AGENDA
PLANNING AND ZONING COMMISSION MEETING
CITY OF CREVE COEUR, MISSOURI
MONDAY, AUGUST 19, 2013
7:00 PM

Application #13-018: Request for approval of an amendment to the City Place Master Sign Plan to include new tenant signs.

**APPLICATION TO PLANNING AND ZONING COMMISSION
#13-018 FOR AN AMENDMENT TO THE CITY PLACE MASTER SIGN PLAN TO
INCLUDE NEW TENANT SIGNS**

City Place 2 Fountain Signage

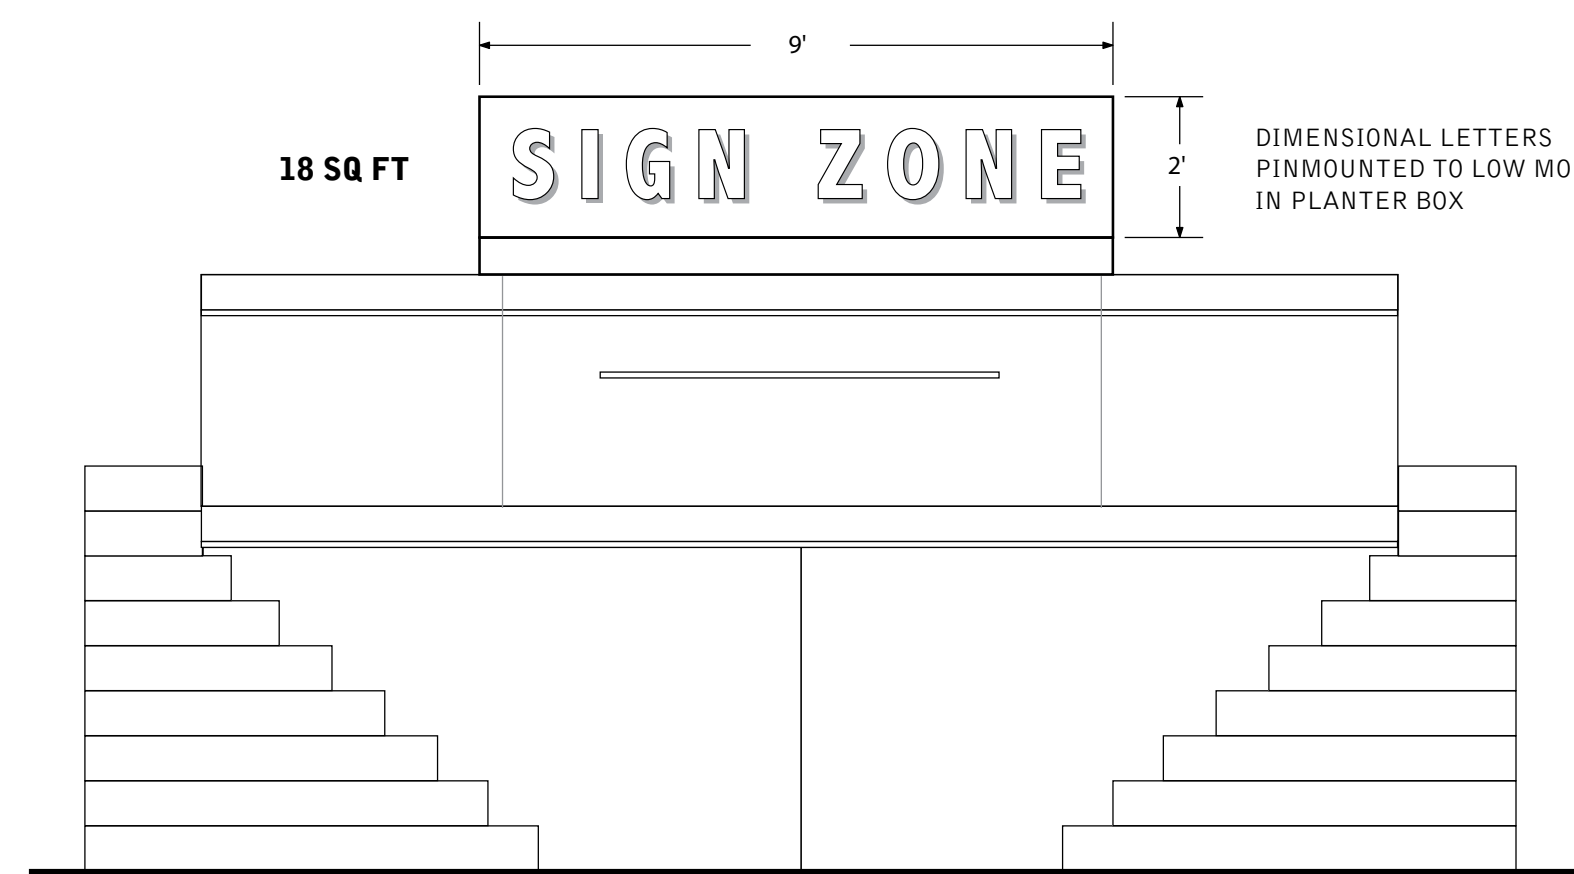
As discussed above, the proposed CityPlace II monument sign is modest in size and appropriately set within the context of the office building entrance. The CityPlace VII wall sign, on the other hand, does not show any particular relationship with the building although its placement is appropriate. It should be noted that the sign is 50% larger than it would otherwise be permitted as a freestanding tenant site if it were not within the master signage plan. Staff believe this is significant since the overall site design does not visually or functionally represent a significant property in the campus, so it is not clear why it should be favored with a particularly large sign; this would seem to be contrary to one of the purposes of the sign regulations that is to promote consistency of opportunity among signs within the city. The signs at the top of the office towers do occupy distinctive and significant locations that set the standard for the campus; the CityPlace VII site is, frankly, a typical retail site and should only be provided a typical retail sign, limited to 50-square feet. If the applicant ultimately reworks this site into the visually significant place that it can be, the proposed wall sign might seem more appropriate.

A ELEVATION: WALL MURAL
NOT TO SCALE

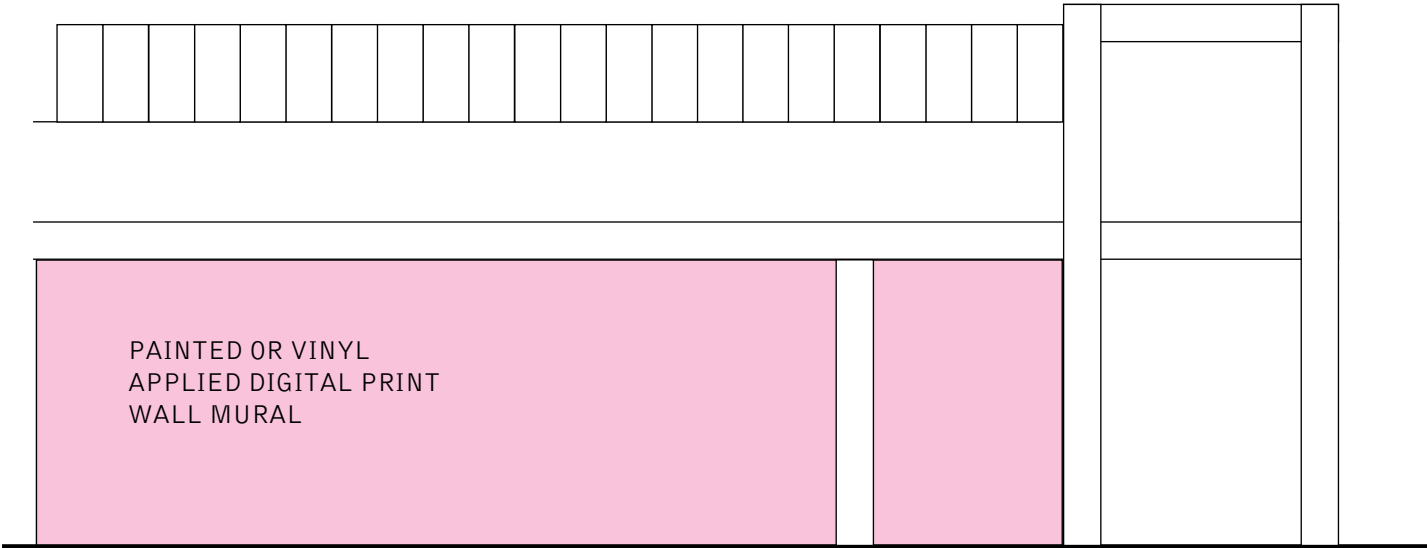
The mural already exists and was used to provide interest on a wall that was being painted anyway. It does not contain any specific tenant information but, as an applied image, it generally constitutes a sign, hence its inclusion here. There do not appear to be any concerns vis-à-vis the Design Guidelines.
